DUKE POWER COMPANY

Re: Catawba Nuclear Station
Docket Nos. 50-413 and 50-414

On April 6 and 7, 1982 (in Bethesda) and April 19-22, 1982 (in Charlotte) representatives from Duke Power, Westinghouse, the NRC Mechanical Engineering Branch (MEB), and Pacific Northwest Labs (MEB consultant) met to discuss agenda items transmitted by Ms. E. G. Adensam's letter of January 29, 1982.

MEB Review Meeting
April 19, 1982

AUXILIARY BUILDING
 AUXILIARY FEEDWATER SYSTEM
 CATAWBA NUCLEAR STATION
 Figure 3.9.3-1
 Rev. 2

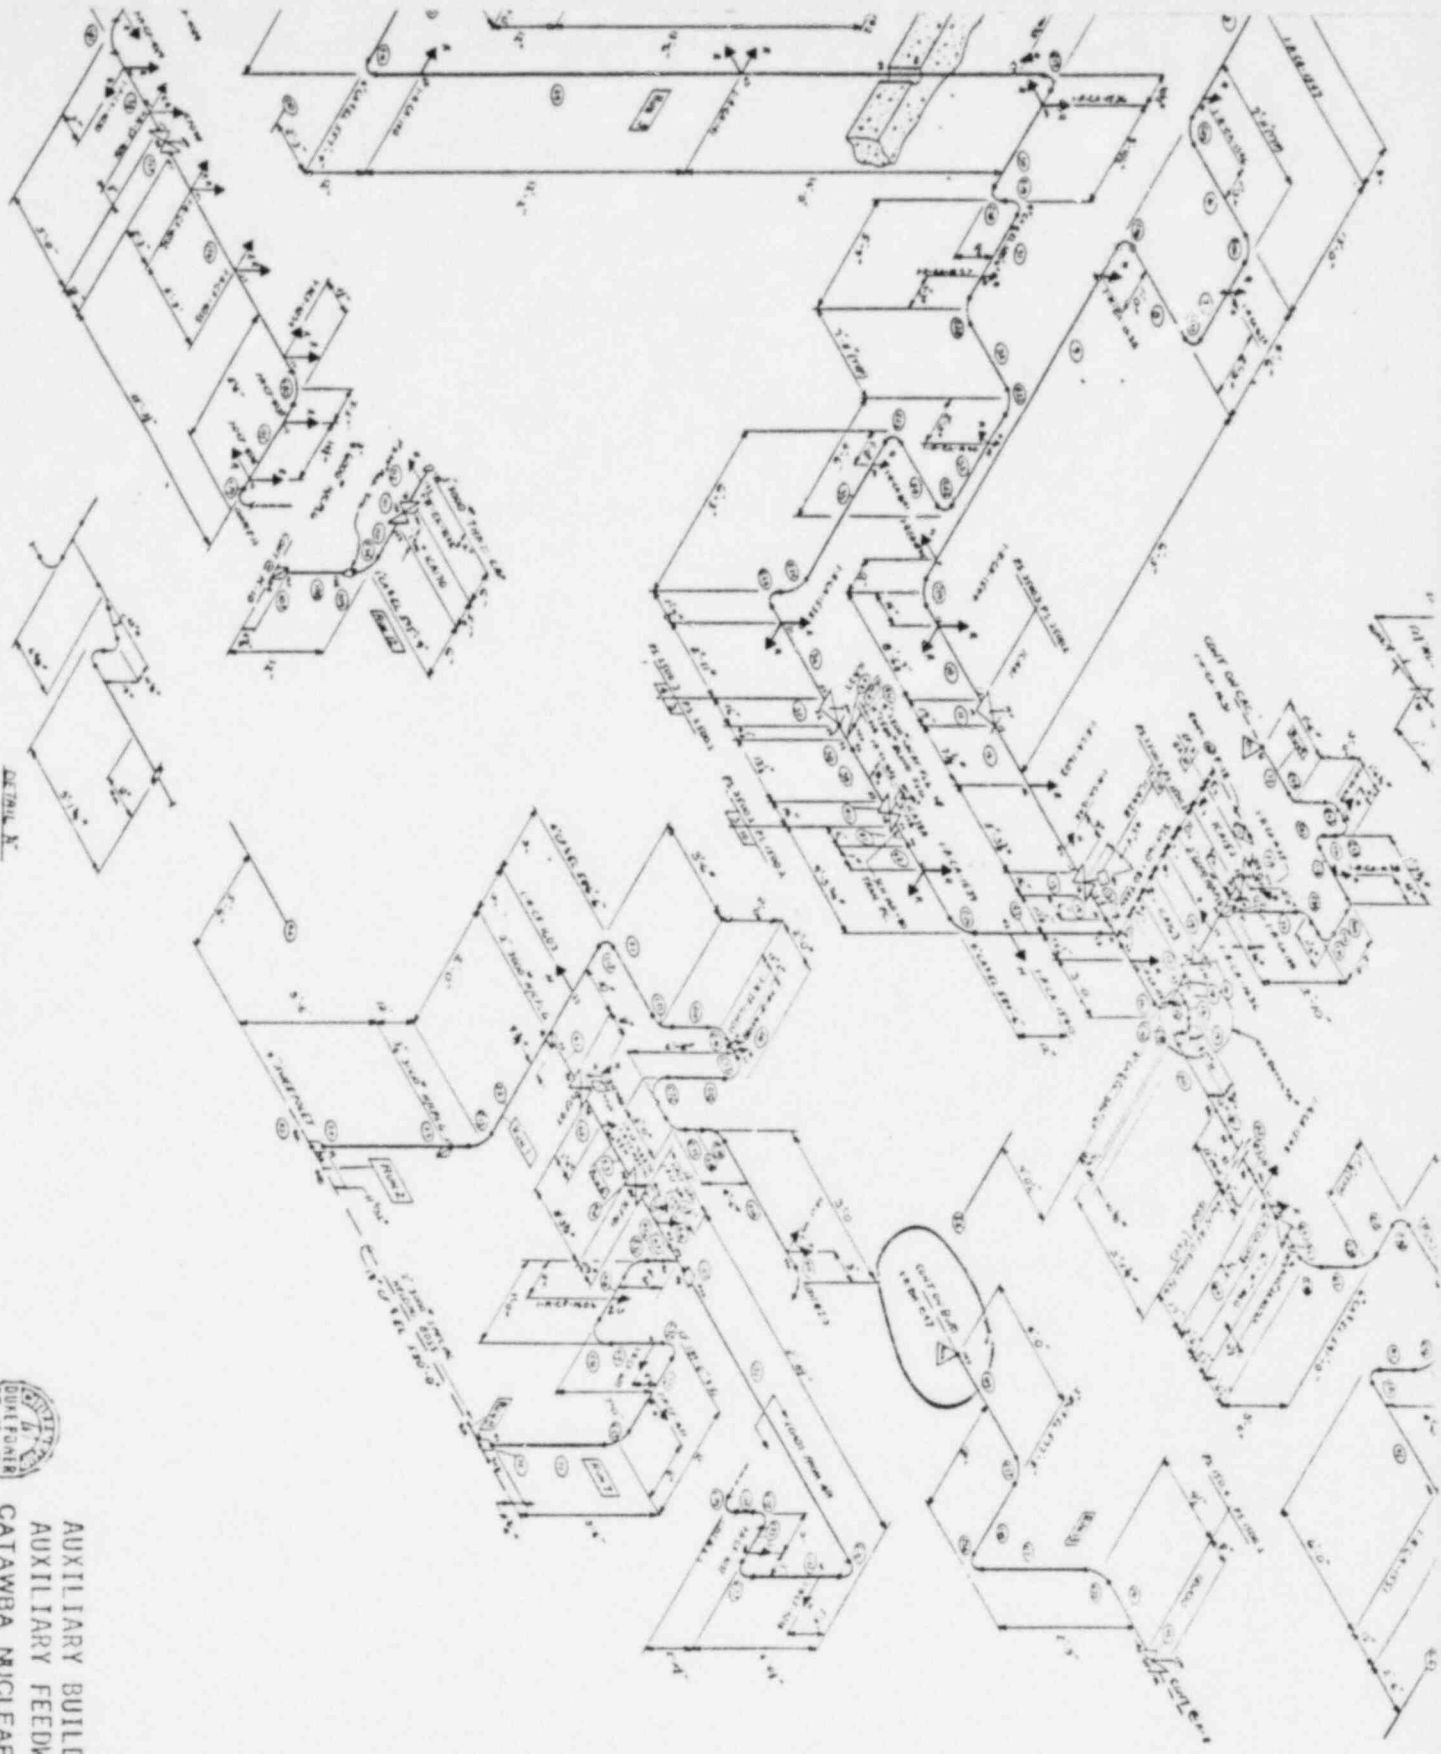
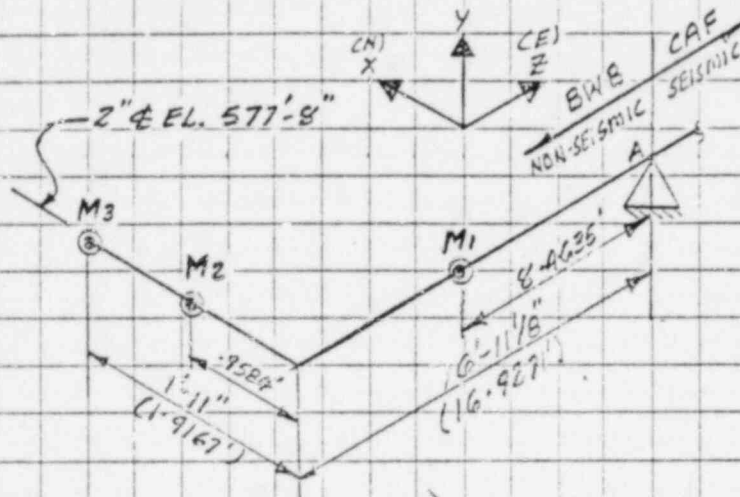
When an anchor is used to separate a seismic boundary non-seismic boundary, a plastic hinge calculation is performed. All the non-seismic supports are assumed to fail and a plastic hinge is formed. The loads developed are absolute summed with the seismic analyzed side. As per Regulatory Guide 1.29, the interface between seismic Category I and non-seismic system is designated as seismic Category I. An example of a plastic hinge calculated for anchor I-R-BW-1547, shown in figure 3.9.3-1, is attached.

FIGURE 3.9.5-1A ENERGY ABSORBING ASSEMBLY

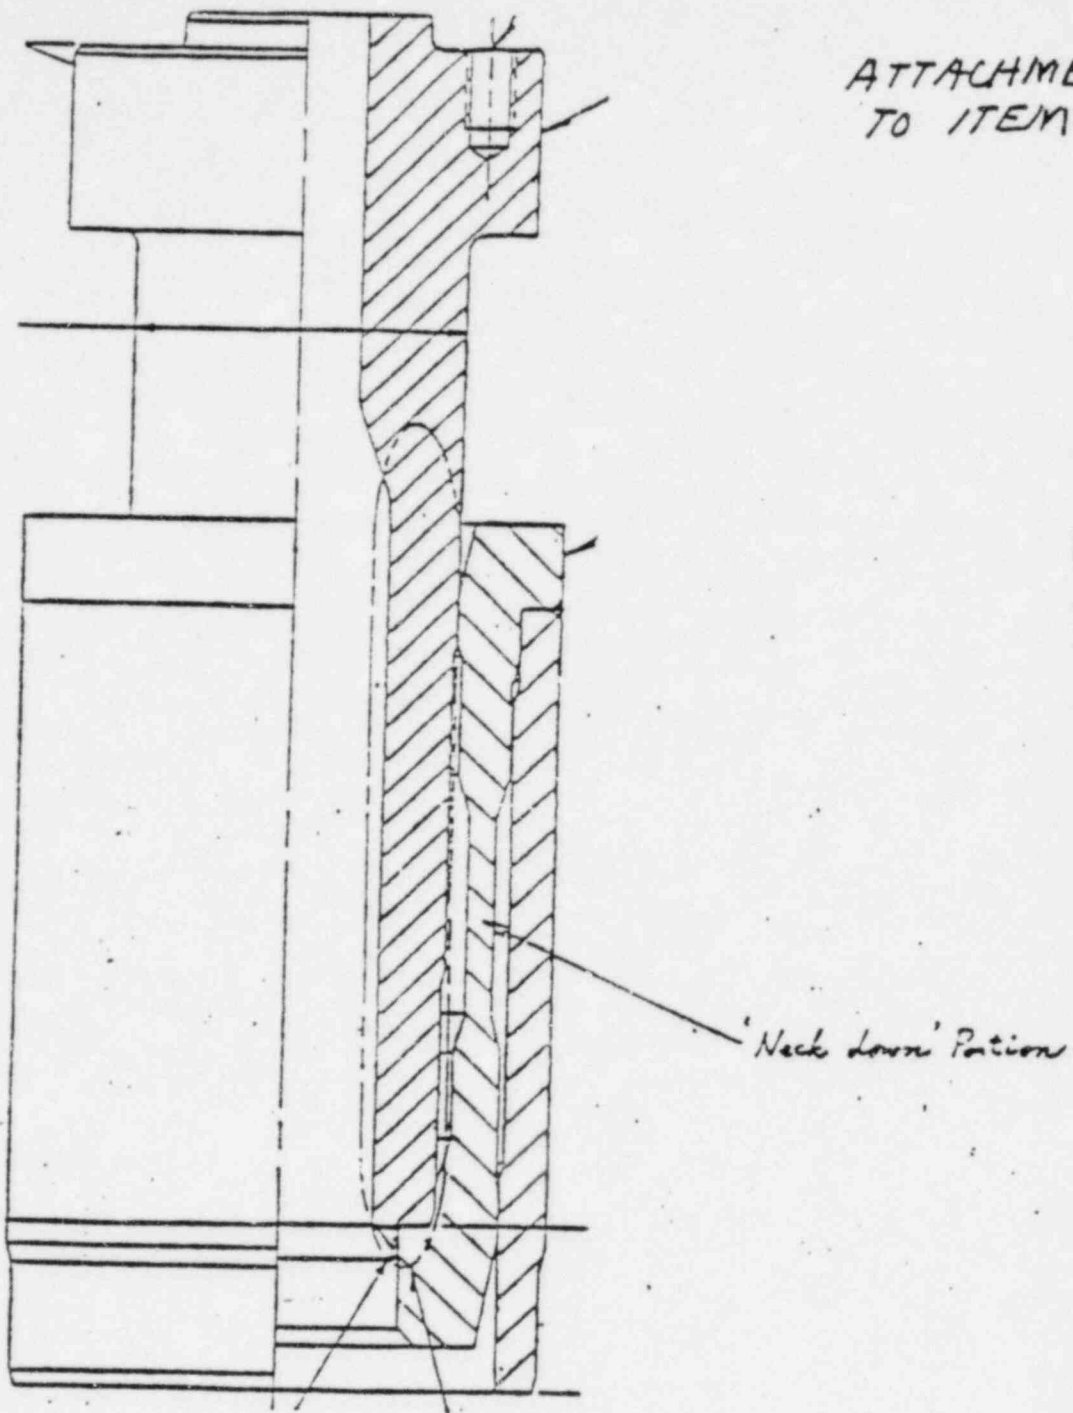
The first full paragraph refers to Figure 3.9.5-1. Provide this figure.

Figure 3.9.5-1 is already provided.

The main purpose of the energy absorber is to absorb impact loads of the core and the supporting structure during a postulated core drop accident. The energy of the impact is absorbed by an energy absorbing mechanism which consist of a "necked-down" portion as shown in Figure 3.9.5-1A. Using energy principles the total potential energy of the system is absorbed by the strain energy of the energy-absorbing devices.

Based on the above discussion and the attached FSAR changes, this item was resolved.

Item 104 - 3.6.2.1.1.1, page 3.6-9

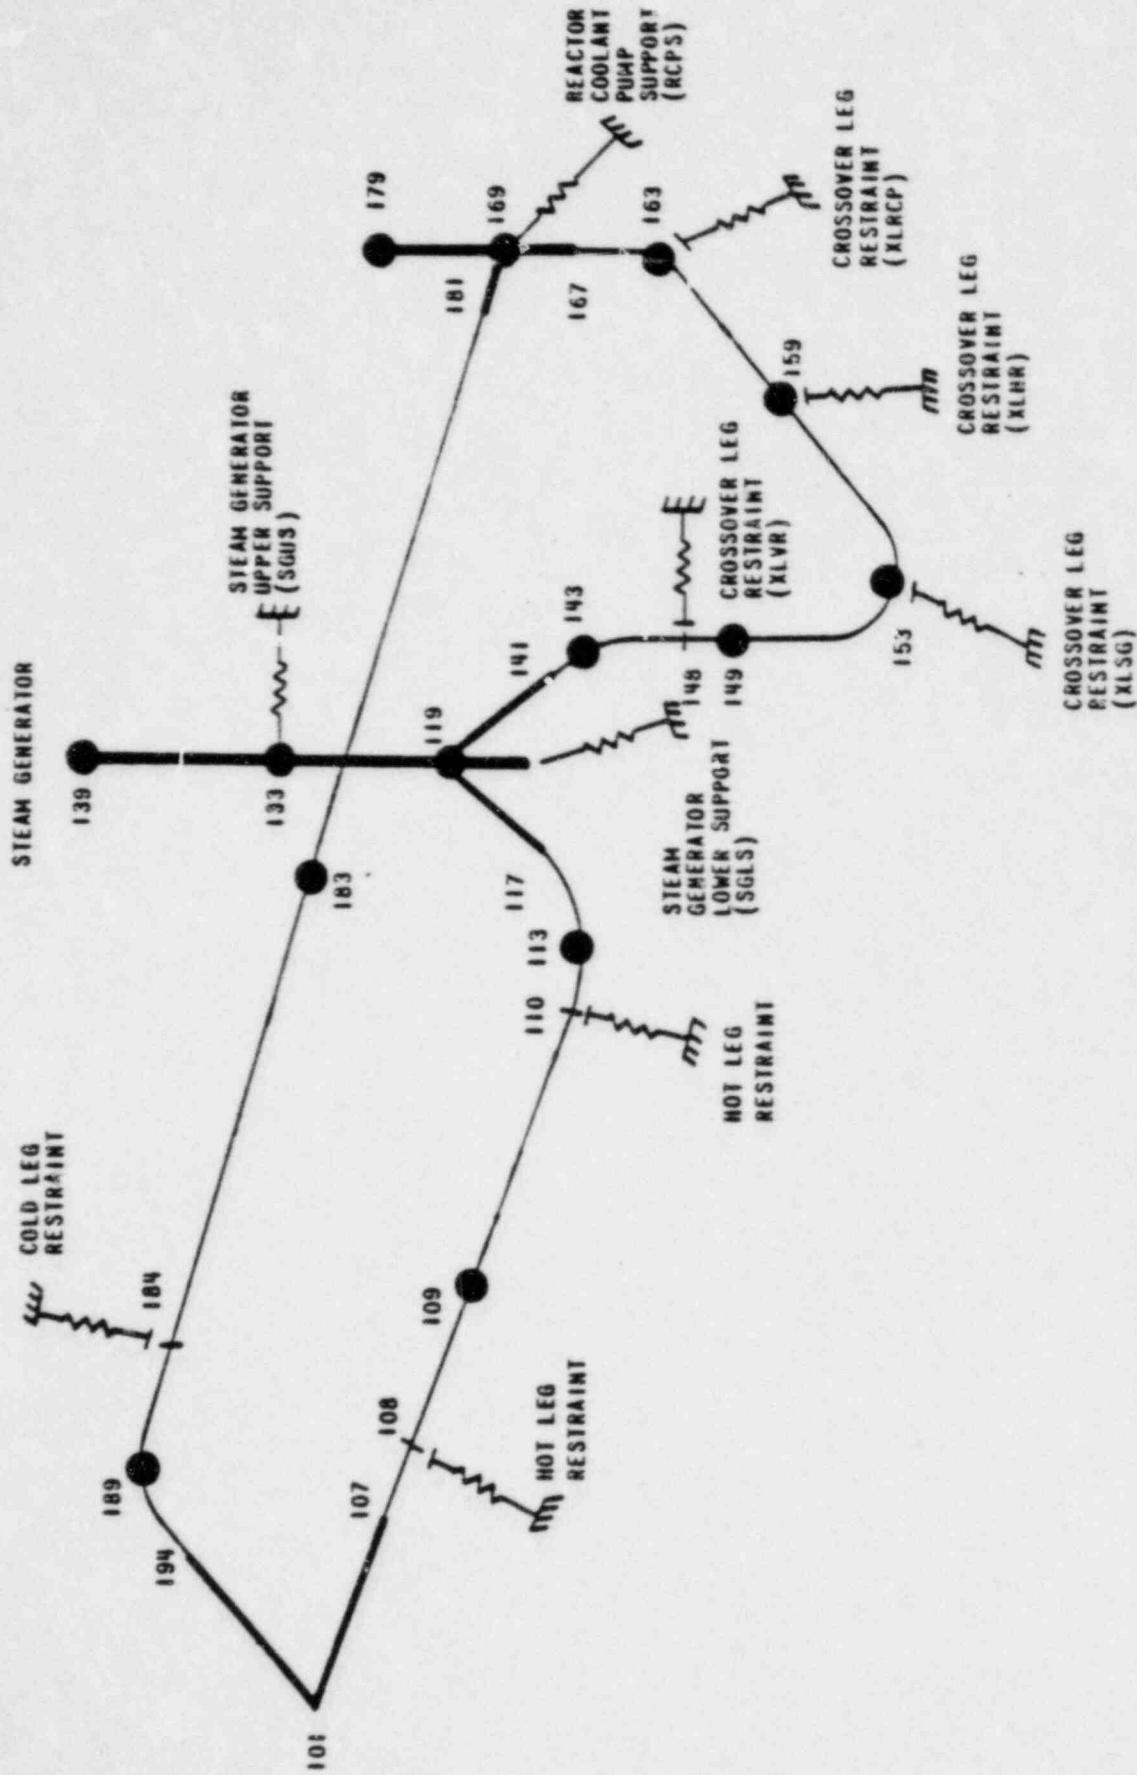
Show locations of pipe whip restraints on the reactor coolant piping and for which breaks in the RCS they are designed.

It was agreed that Figure 3.6.2-4 would be revised to indicate the location of pipe breaks and restraints for the RCS.
